RE: **Planning Commission Recommendation to Deny Staff Recommendation on Barton Springs Pool General Grounds Improvements (Case No. C20-2013-001)**

Agenda Item: 6a. Barton Springs Pool General Grounds Improvements SPC-2012-0104D

SUBJECT: Barton Springs Pool, SPC-2012-0104D

SUBJECT: Urban Forestry Board Comments on the Barton Springs Grounds Improvements

**TOTAL SITE
Impervious Cover Calculations**

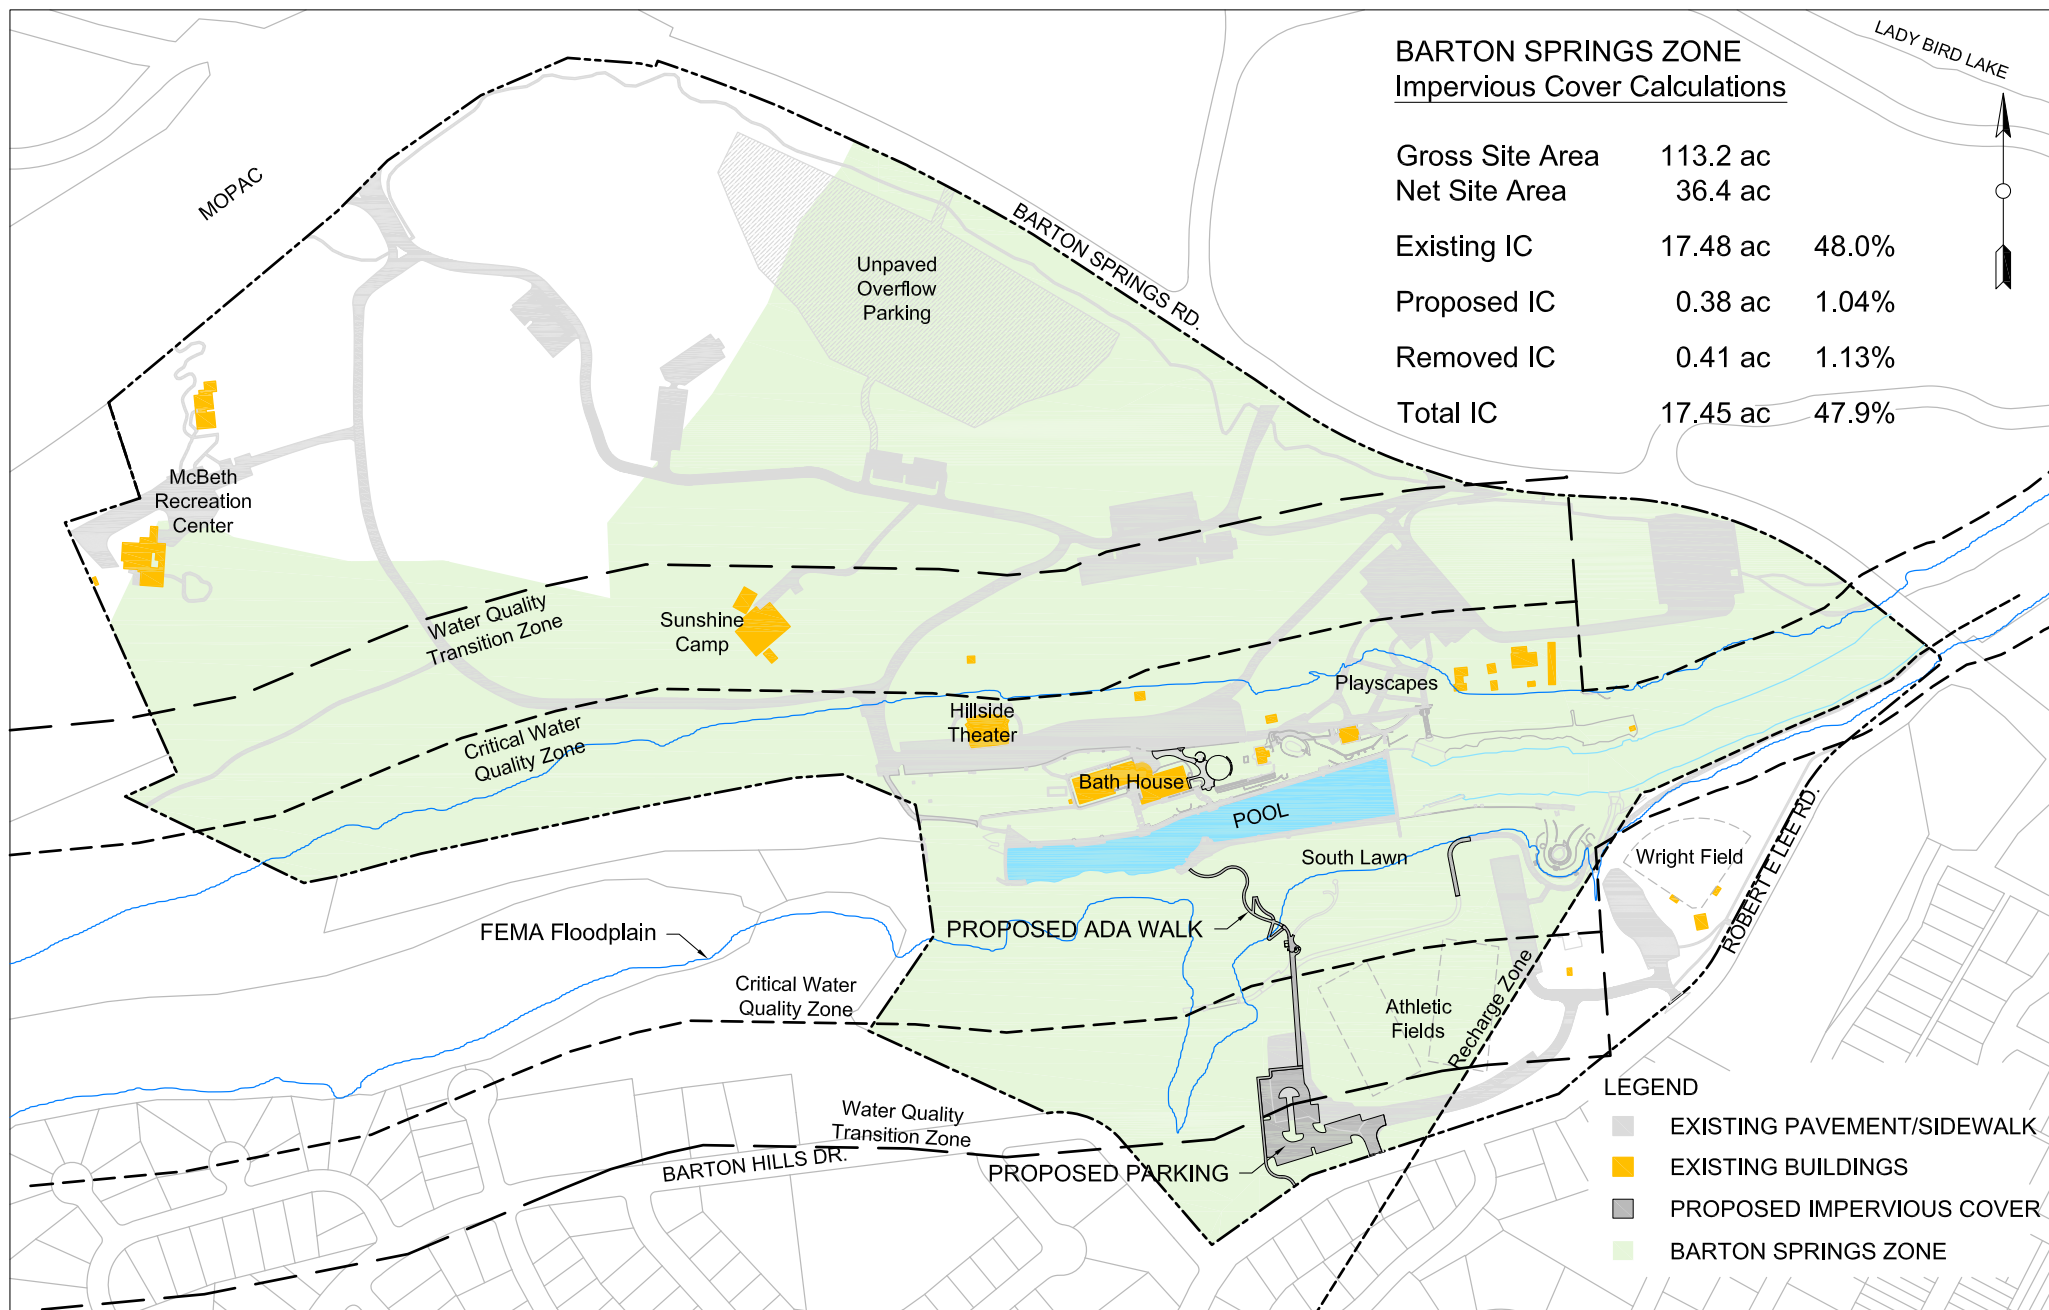
- Preparing a cost-benefit analysis of re-arranging/offsetting parking on the South side to minimize impervious cover in the Water Quality Transition Zone ("WQTZ"); and
- Reducing total impervious cover as a result of this improvements project.

1. Removal of the walkway to the "overlook" on the south lawn;
2. Removal of existing impervious cover on the Barton Springs site as mitigation for the construction of the concrete parking lot in the Water Quality Transition Zone of Barton Creek, with the goal of no increase in the percentage of impervious cover in the Barton Springs Zone.

As for the need to further mitigate for the impervious cover associated with the concrete parking lot, the Board recommends removing a portion of existing impervious cover in order to more closely comply with the 15%
